# UNITED STATES PATENT AND TRADEMARK OFFICE

10/553,864

<b>Office Action Summary</b>	<b>Application No.</b> 10/553,864	<b>Applicant(s)</b> BICHLER ET AL.	
	<b>Examiner</b> JUSTIN LOFFREDO	<b>Art Unit</b> 4157

**FIG. 8**

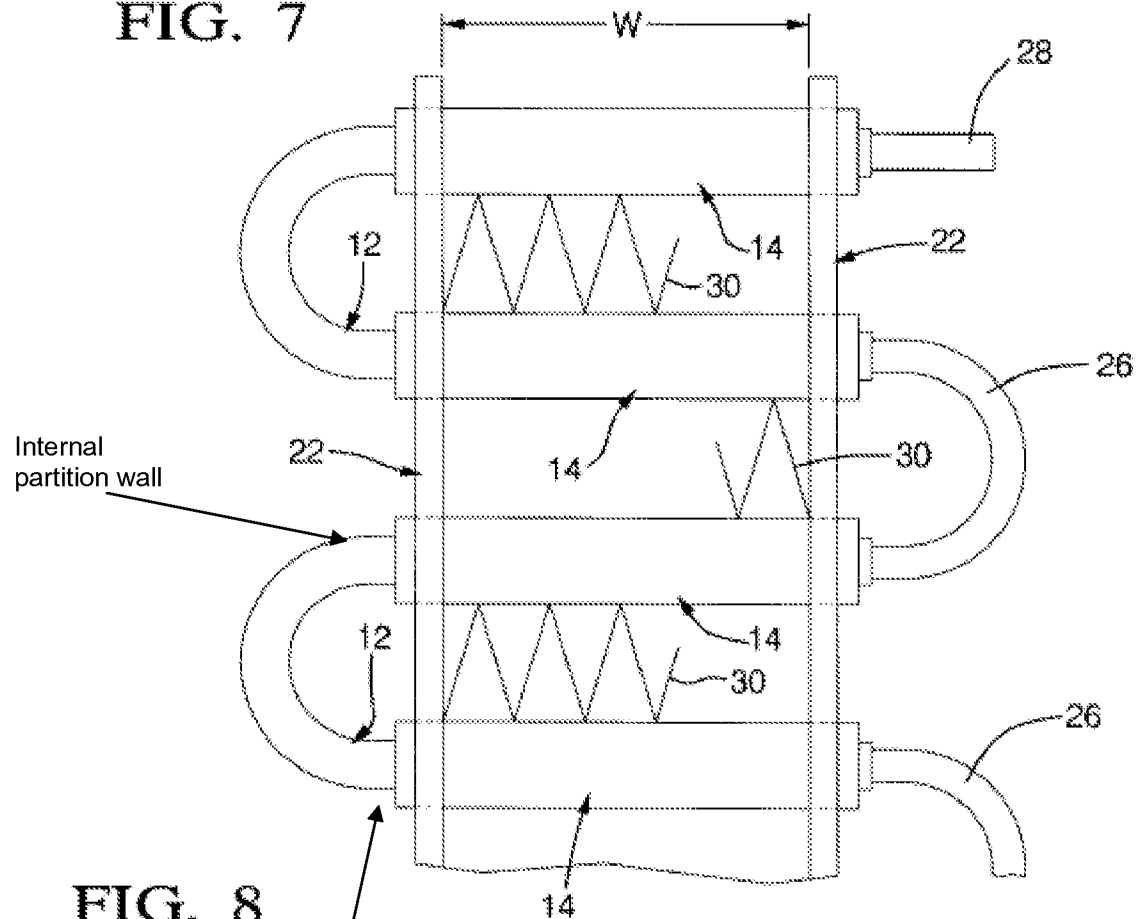
**Consider claim 1.** Ghodbane teaches a combined fluid-air heat exchanger having at least two separate duct systems, an inner tube (12) and an outer tube (14) (col. 3, L 6-7), through which separate material flows (col. 5, L 8-9) may be directed, wherein at least one of the two duct systems (14) has a free surface which may be brought into thermal contact with a directed air flow, and the at least two duct systems are at least partially in thermal contact with one another (col. 5, L 22; Fig. 8). The heat exchanger

**Consider claim 2.** Ghodbane teaches the two duct systems implemented in the form of a first pipeline (14) having a first pipe internal diameter  $d_1$ , in whose pipe interior a second pipeline (12), having a second pipe internal diameter  $d_2$ , with  $d_2 < d_1$ , is provided, the first duct system being delimited by the second pipeline (12) and the second duct system being delimited by the first (14) and second pipeline (12), and the first pipeline (14) having a free pipe outside (col. 3, L 4-16; Fig. 8).

**Consider claim 3.** Ghodbane teaches fins (30), which are lamellar plane elements attached (brazed and fixed together to complete a rigid core (32)) to the pipe outside of the first pipeline (14) (col. 4, L 30-32; Fig. 8).

**Consider claim 4.** Ghodbane teaches the two duct systems implemented in the form of a shared pipeline, the pipeline having a pipe surface (see Fig. 8 below), and the pipeline has at least one internal partition wall, which divides the volume enclosed by the pipeline into at least two separate pipeline longitudinal parts and via which the at least two pipeline longitudinal parts are in thermal contact with one another. As taught by Ghodbane, the two fluid media are kept totally separate, but are thermally conductive to and from one another across the shared walls of the inner tubes (col.5, L 21-24).

**Consider claim 5.** Ghodbane teaches fins (30), which are lamellar plane elements attached (brazed and fixed together to complete a rigid core (32)) to the pipe outside of the first pipeline (14) pipe surface (col. 4, L 30-32; Fig. 8).
